APPEAL SUMMARY

Appeal ID: 24096	Project Address: 1417 NW 20th Ave
Hearing Date: 10/21/20	Appellant Name: Benjamin Riemer
Case No.: E-002	Appellant Phone:
Appeal Type: Electrical	Plans Examiner/Inspector: Chandra Alvey, Brian Crise
Project Type: commercial	Stories: 7 Occupancy: Mixed Construction Type: I-A, III-A
Building/Business Name: Block 290 Apt	Fire Sprinklers: Yes - Throughout
Appeal Involves: Erection of a new structure	LUR or Permit Application No.: 20-182443-CO
Plan Submitted Option: pdf [File 1]	Proposed use: Mixed Occupancy

APPEAL INFORMATION SHEET

VTHP Side Access Closet - Plan Detail

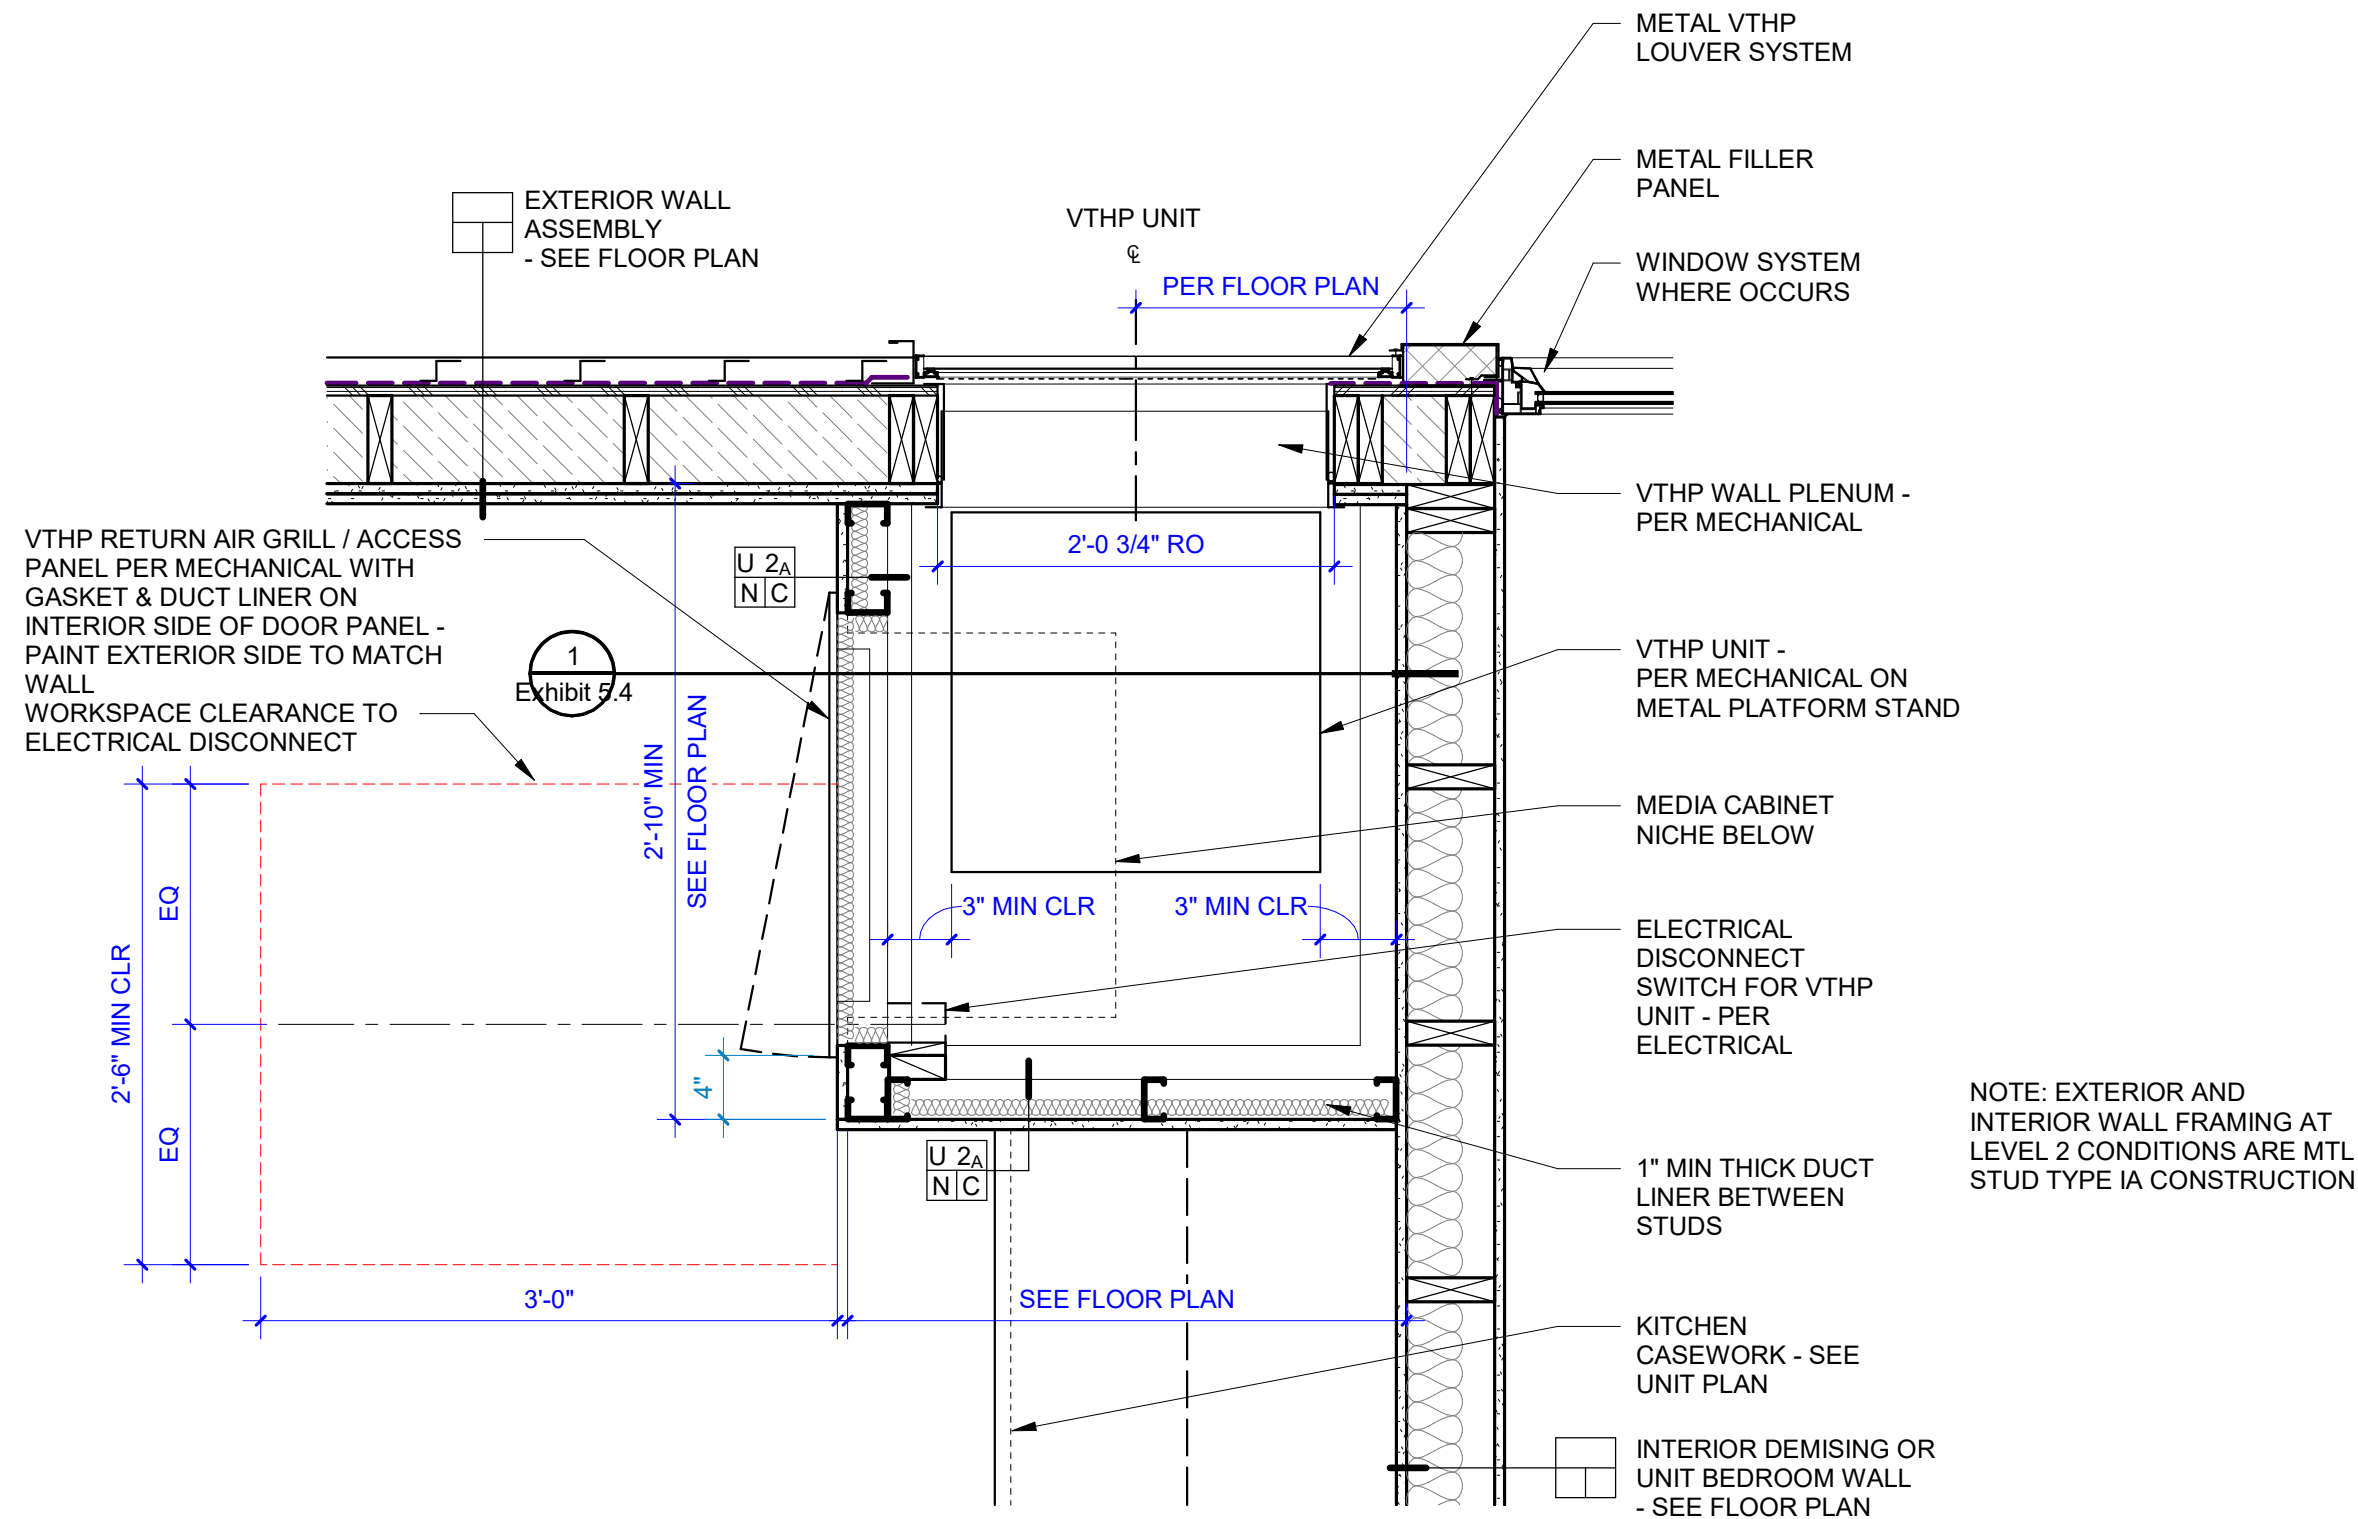
Code Section	2017 OESC SECTION 100.26 Space About Electrical Equipment, 110.26(A)(1) Depth of Work Space.
Requires	110.26(A)(1) and Table 110.26(A)(1) Condition 1 for electrical equipment less than 150 Volts require 3ft minimum deep clearance perpendicular to live parts that require maintenance while energized.
Code Modification or Alternate Requested	That the access to the electrical equipment for the Vertical Terminal Heat Pump (VTHP) units located in a dedicated closets may be allowed, where access located perpendicular to the back of the VTHP units and live part is not possible, to have access located to the side of the equipment in general compliance with requirements for Limited Access Section 110.26(A)(4)
Proposed Design	<p>The proposed design is a mixed-use building with 5 stories of Type III-A construction over 2 stories of Type I-A construction. The primarily use above the ground floor is R-2 occupancy apartment units, with accessory S-1 and A-2 & A-3 occupancies. The entire building is equipped with a NFPA 13 automatic fire sprinkler system. Heating and cooling is provided for the residential units by VTHP units located in dedicated closets on the exterior walls of the units.</p> <p>The proposed design provides side access to a limited number of the VTHP closet in the project, as indicated in exhibits 5.1 & 5.2. A separate power disconnect switch is provided with direct access from the clear working space provided in front of the access panel for the VTHP closet to allow for the power to be turned off to the unit prior to servicing. Refer to Exhibit 5.3 & 5.4 for layout details of side access VTHP closet. The 29"w x 59"h access panel can open great than 90 degrees and also can be easily removed from the opening to facilitate access to the VTHP unit in the closet for maintenance and removal. The closet provides a minimum 8 inches clear from the back of VTHP unit to the back wall of the closet.</p>

Reason for alternative	The exterior design limits locations available for the placement of the VTHP closets and the kitchen layout in units prevent locating an access panel on the back of the closet to provide

perpendicular access to the pack of the VTHP units. By providing a side access panel to the closets with the added electrical disconnect switch we believe the proposed configuration provides adequate access and protection for the examination, adjustment, servicing and maintenance of the VTHP units that meets the intent of the limited access requirement of NEC section 110.24(A) (4).

Electrical access to Vertical Terminal Heat Pump Units from side in lieu of from the front: Hold for additional information.
